ADDENDUM #2

Reference: Physical Education Building Infill
Utah Valley University, Orem, Utah
Project No. 09097790

ADDENDUM - 1

Project: UVU PE Infill II
DFCM Project Number: 09097790
Axis Project Number: 0910
To: Mike Ambre
From: Axis Architects
Date: August 5, 2009

A2 PLUMBING FLOOR PLAN

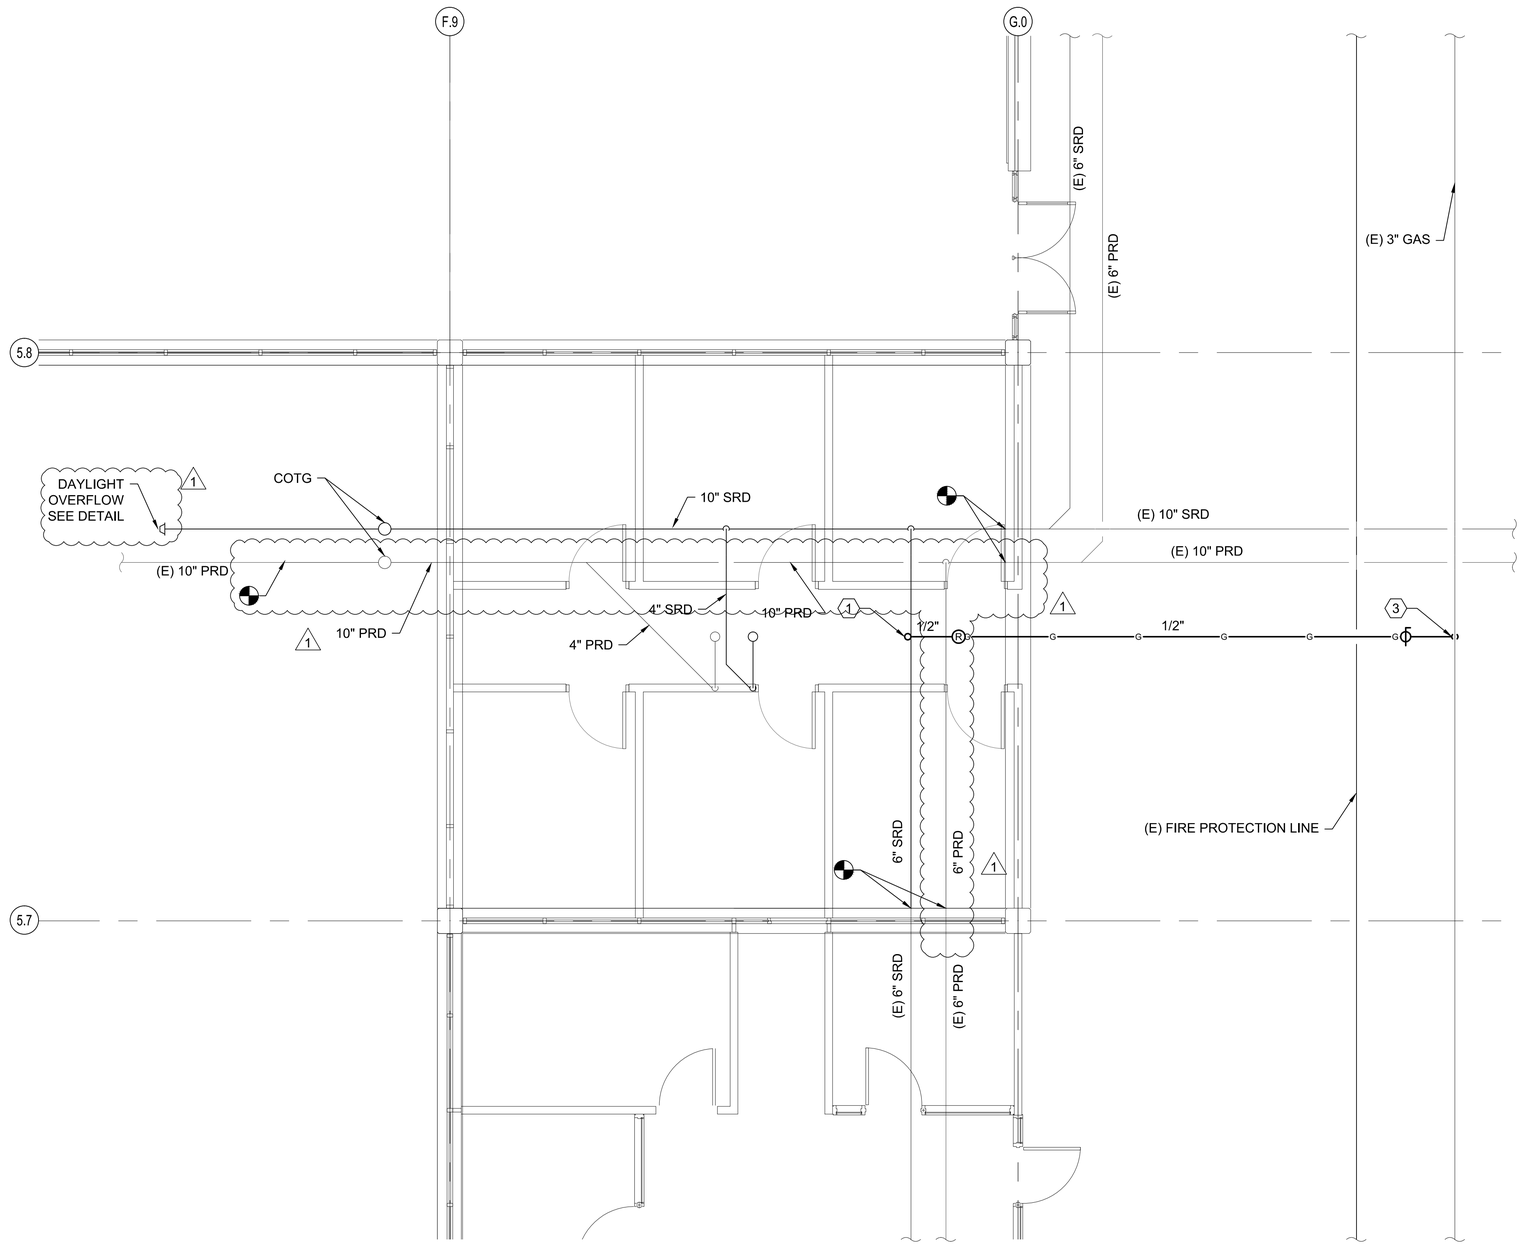
Item III-1. Sheet PE101: According to as-built drawings, the existing roof drain line is approximately 15' below grade. Coordinate with the G.C. to provide excavation, shoring, backfill, landscaping repairs, etc. as necessary to make connections to this line. Take care to protect adjacent building, footings, landscaping, utilities, etc. as required. Existing concrete piping below new building envelope to be replace with cast iron. See attached drawing.

C2 ROOF DRAIN ISOMETRIC DETAIL
SCALE: NONE

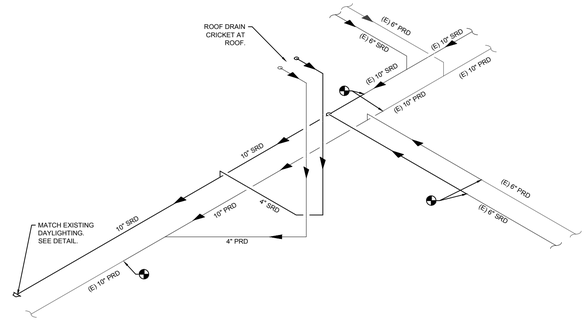
Item III-2. Sheet PE501: Details C2 and C4 have been added.
